SERVICE BULLETIN

M1359 2019-02-22

M1359: 2014 - 2016 TOURING - HYDRAULIC CLUTCH LINE REPLACEMENT

Figure 2. Copper Washer Orientation

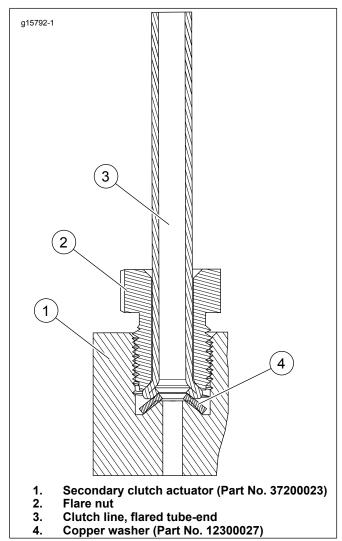
- If the leak is still present, remove the secondary clutch actuator to inspect the secondary clutch actuator cavity. See service manual for removal instructions.
- Remove clutch line and hold actuator with cavity facing up.

Copper washer can only be installed in secondary clutch actuator once. It is very difficult to remove from the cavity after it has been in service. A clutch line may be installed multiple times on an actuator with a copper washer installed as long as a seal can be achieved.

Check to see if copper washer is installed or being added for the first time.

- See Figure 2. Hold secondary clutch actuator upright. Install copper washer (Part No. 12300027) in the actuator cavity. Allow copper washer to self-center.
- 3. Tighten the clutch line flare nut to initial torque.

Torque: 10.9–16.3 N·m (96–144 in-lbs) Clutch line flare nut - initial torque

- 4. Install secondary clutch actuator. See service manual.
- 5. If leak still persists increase torque to secondary torque.

Torque: 16.3–22.6 N⋅m (144–200 in-lbs) Clutch line flare nut secondary torque
- 6. If a leak is still present, replace the secondary clutch actuator (Part No. 37200023).
- 7. Verify proper clutch operation.
